TACKLE BOX

RESTAURANT RENOVATION AND DECK ADDITION

Planning Review Board
Revision

Pages now labeled Approved or Revised
with short description. Narritive Attached

Drawing:
**Proposed
FAR Information
Item #14.1**

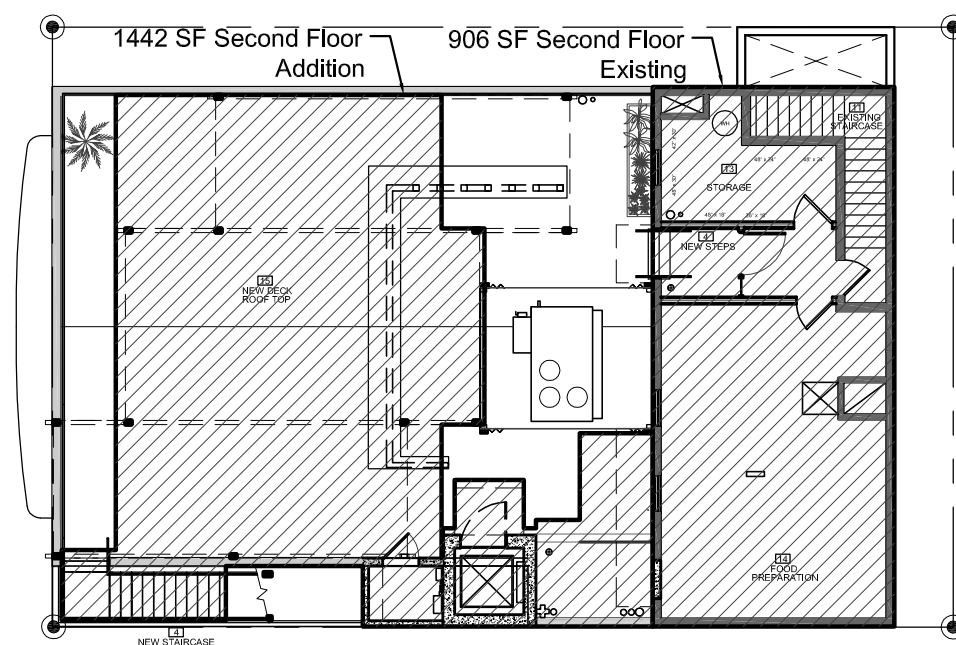
PROPOSED
(NOTE RETRACTABLE AWNING NOW
ADDED TO FAR TOTAL)

Drawing:
Existing First Floor
Item # 19.1

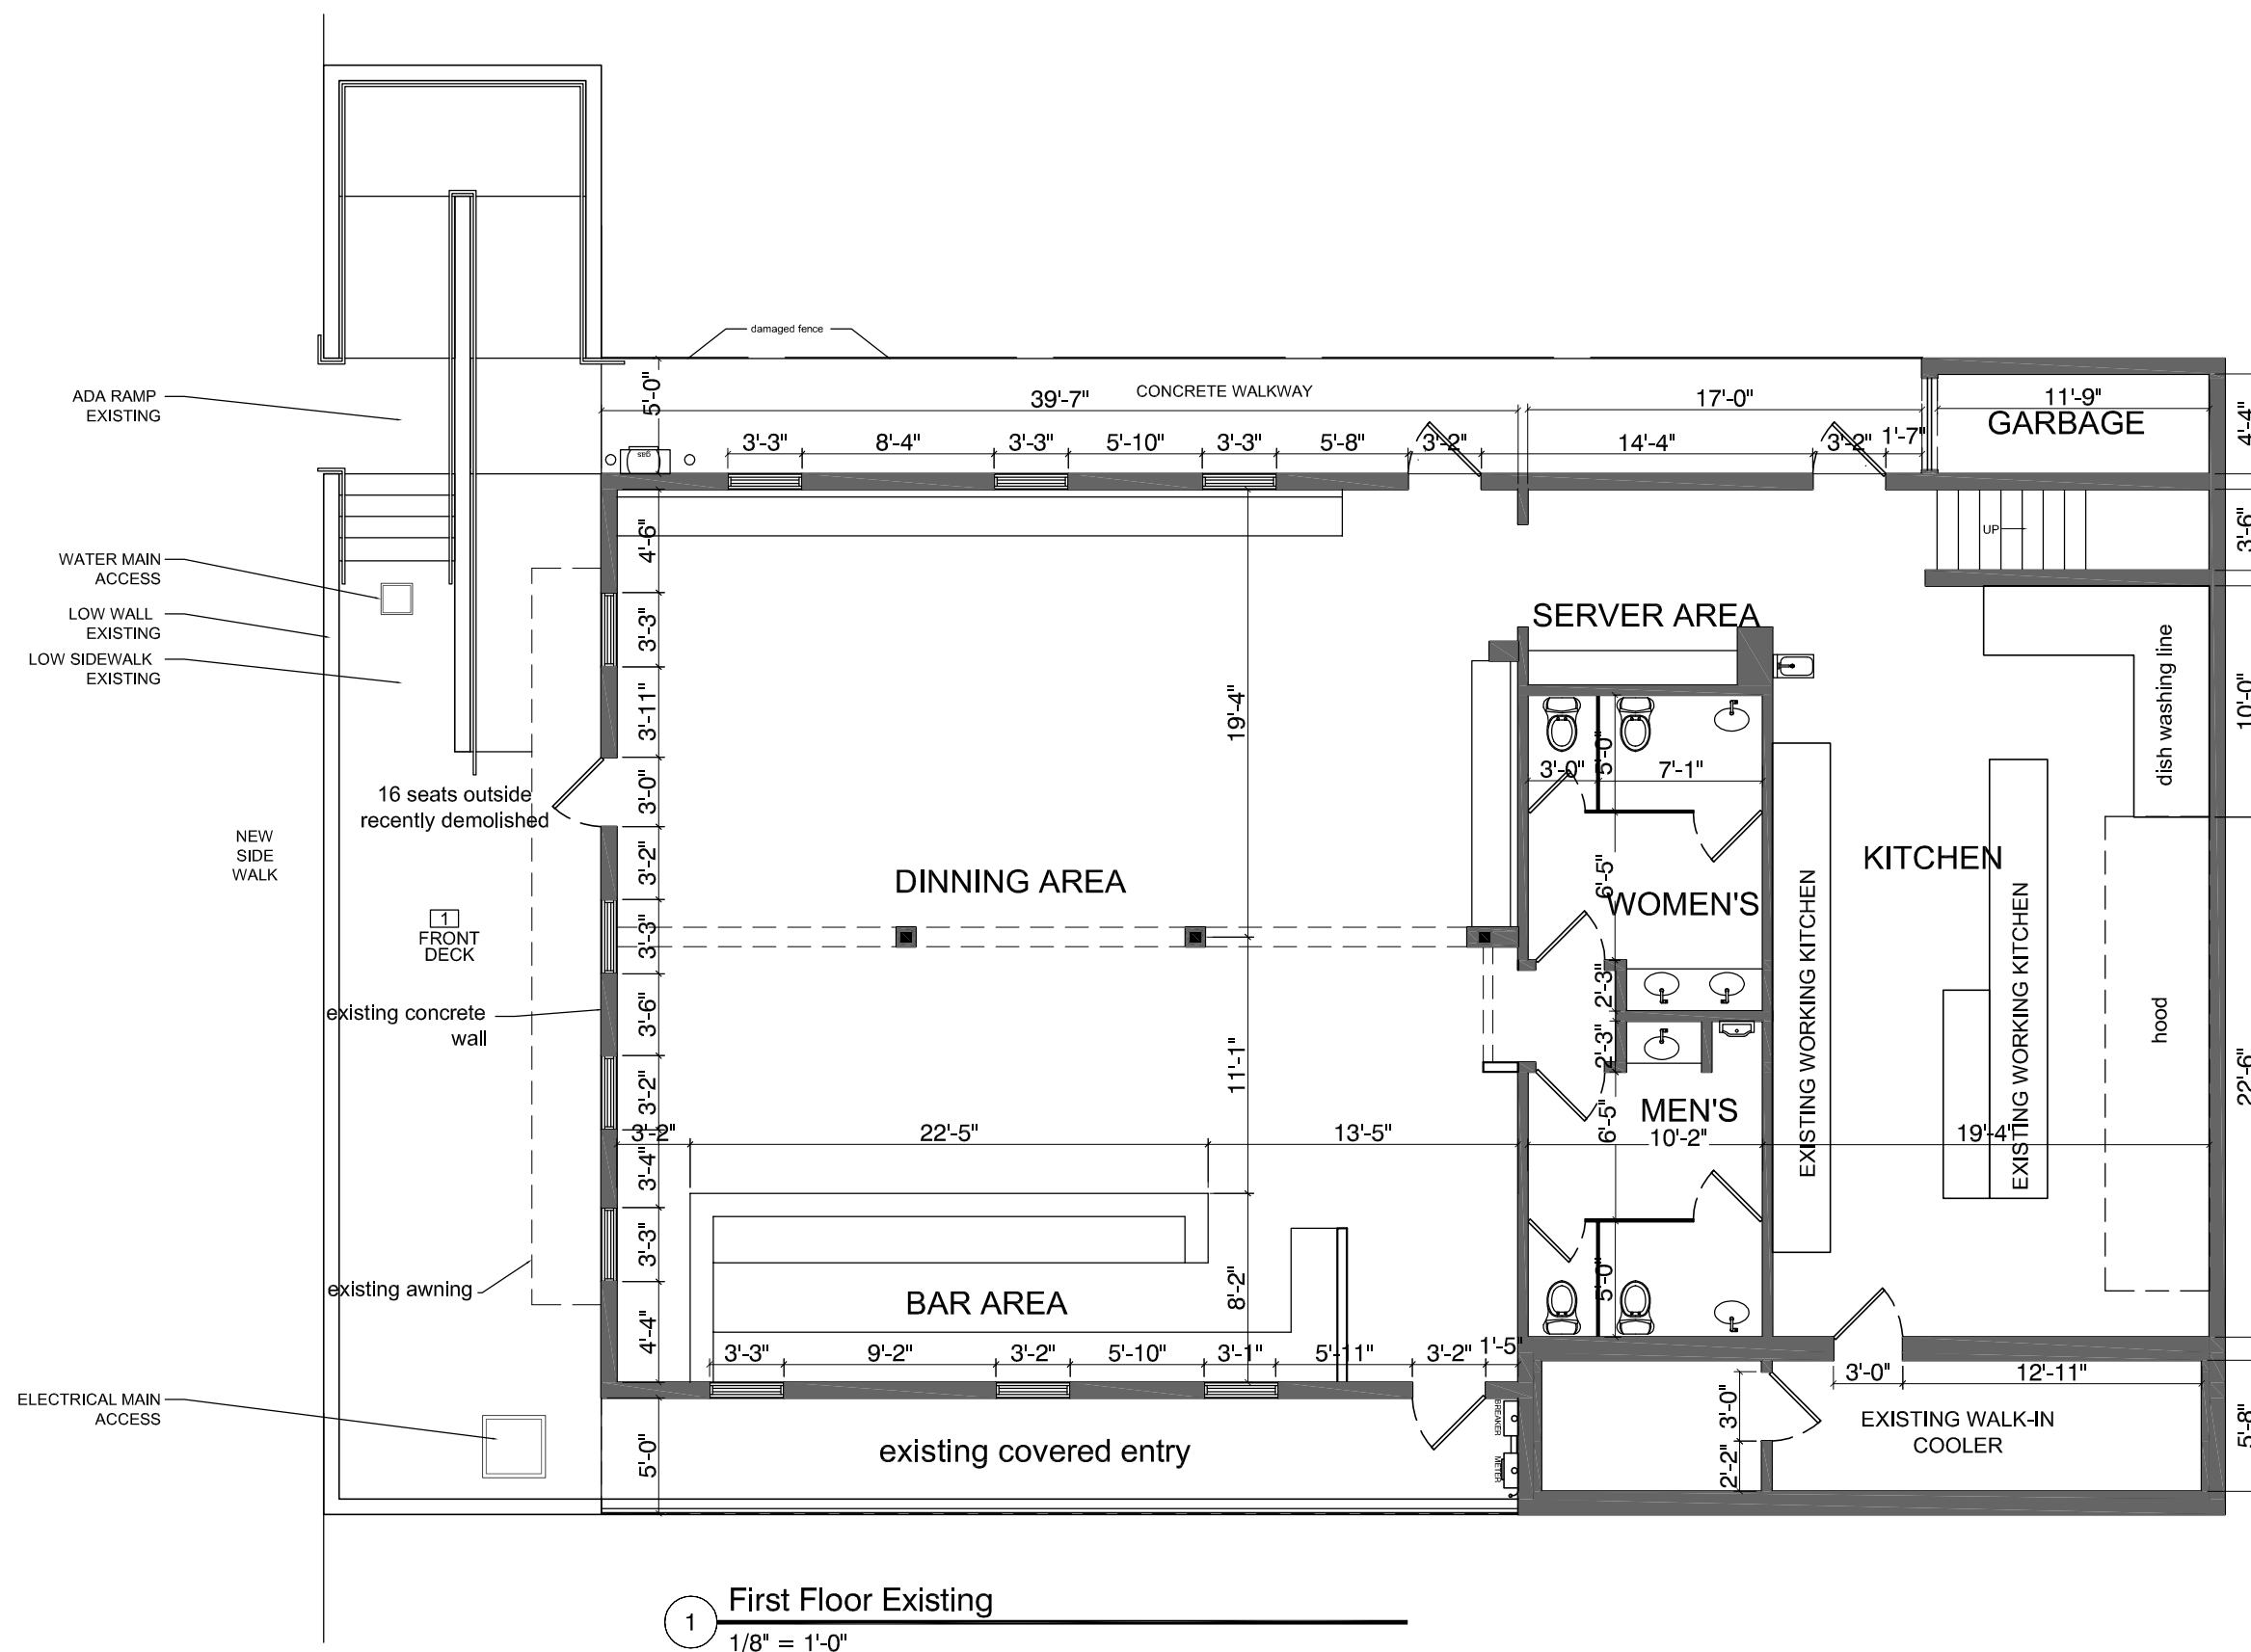
APPROVED 12/15/15
-SIDEWALK ELEVATION BY CITY HAS CHANGED

Drawing:
Demolition Plan
First Floor
Item #20.1

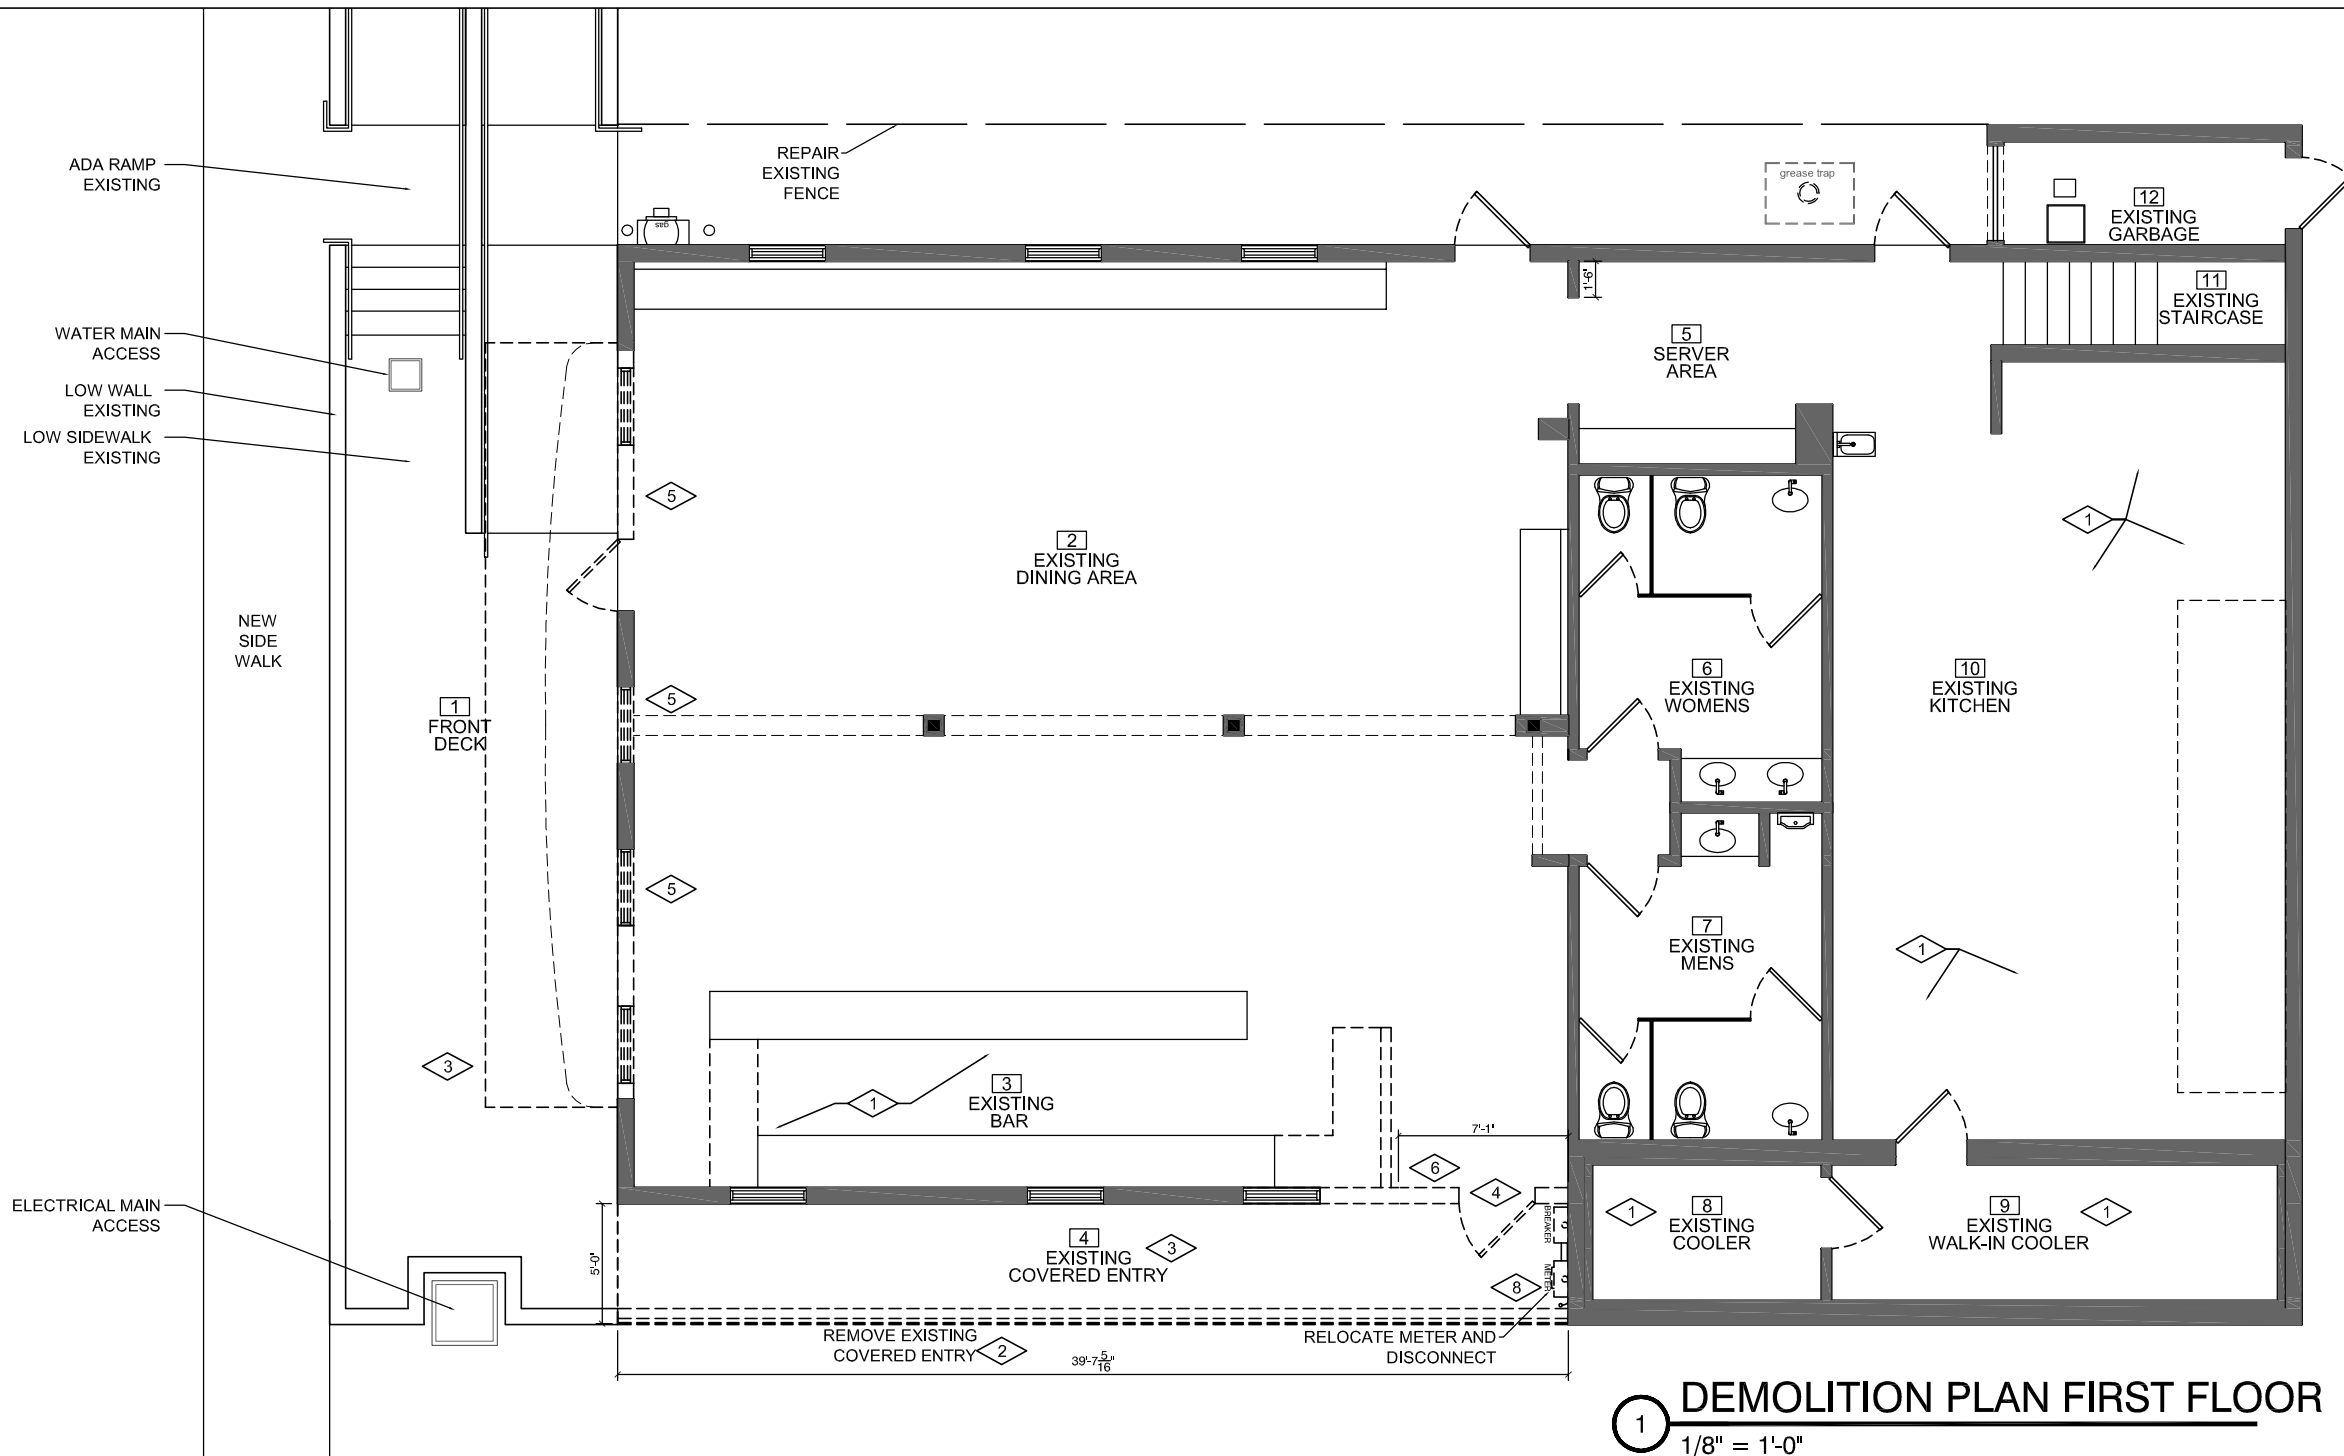
PROPOSED CHANGES/ SITE CHANGES
-ROLL UP STOREFRONT REVISED
-CITY SIDEWALK RENOVATED

Drawing:
**Demolition Elevation
Front / Rear
Item #20.4**

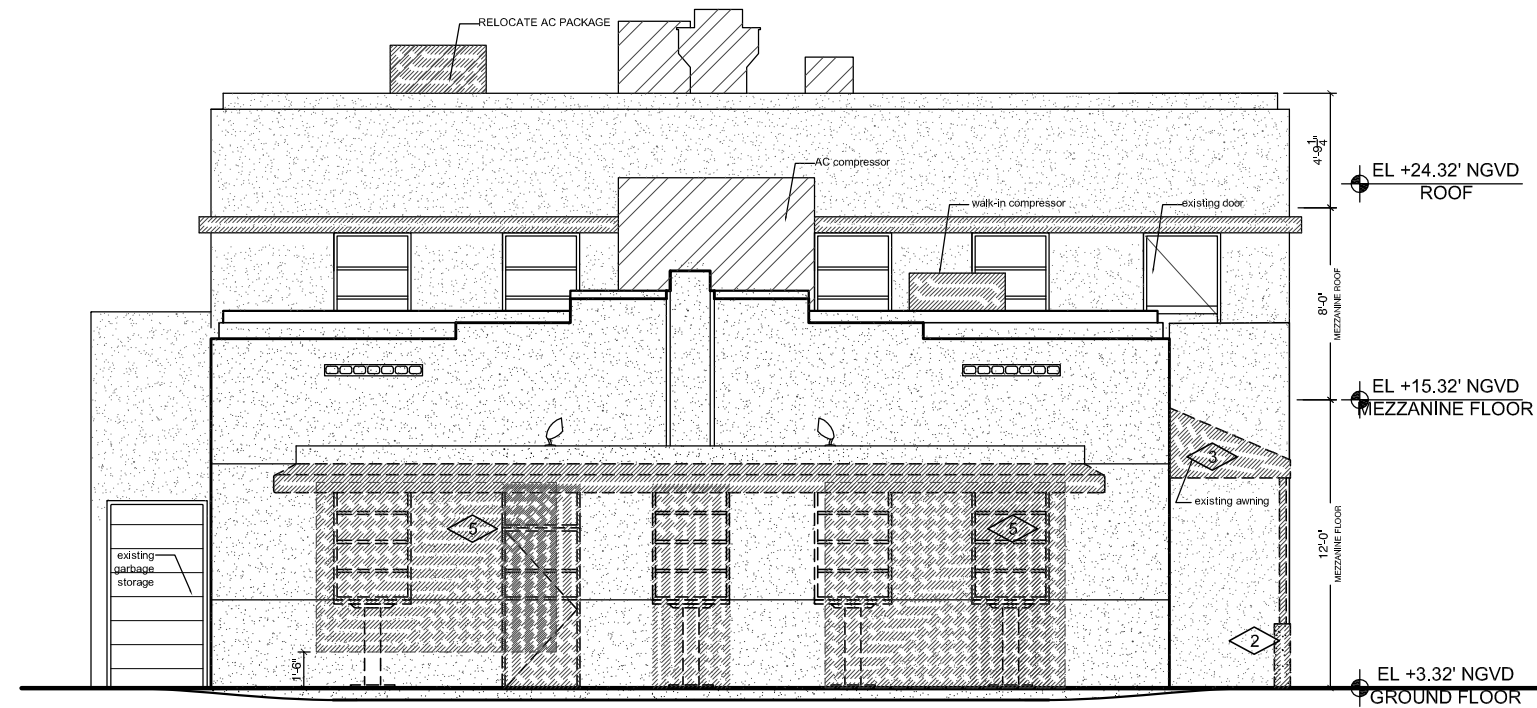
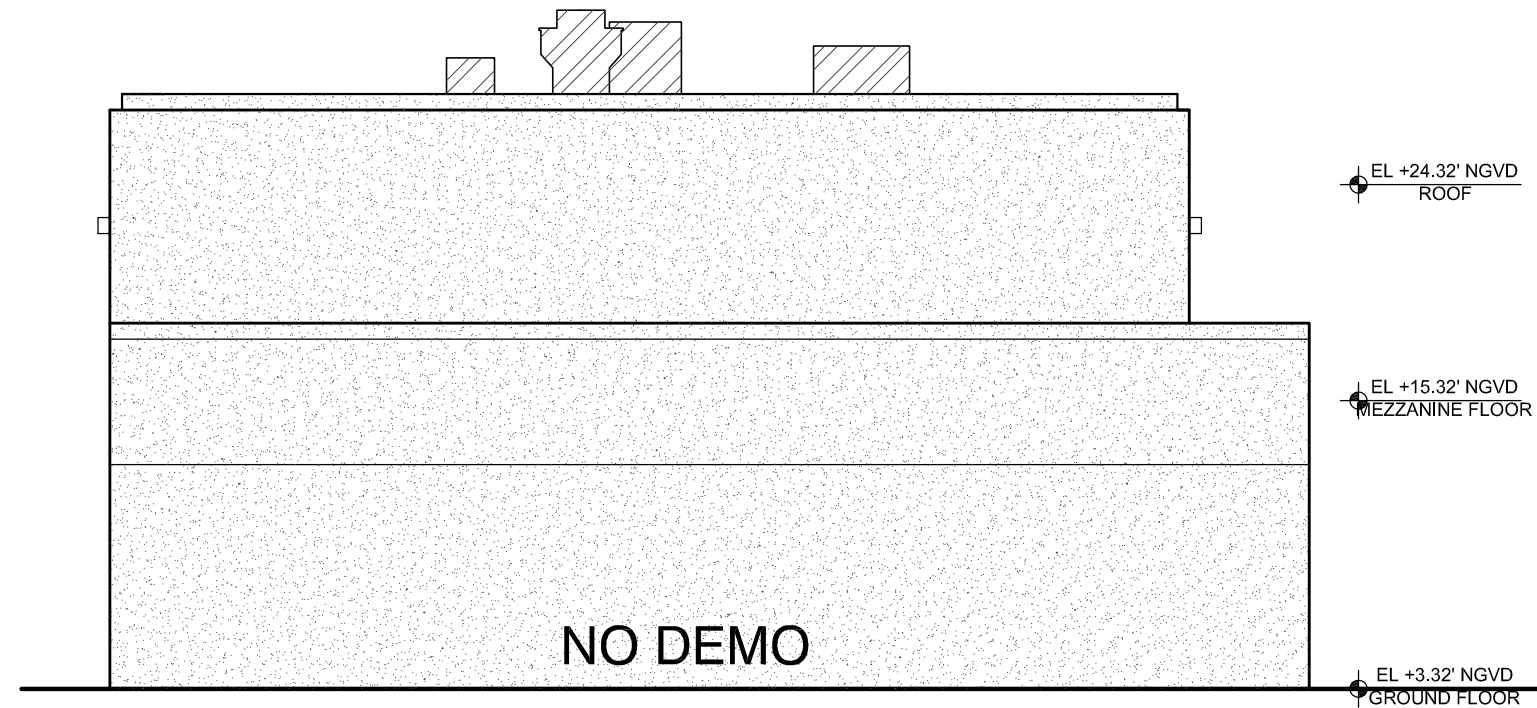
PROPOSED CHANGES/ SITE CHANGES
-LARGER OPENING FOR ROLL UP STOREFRONT
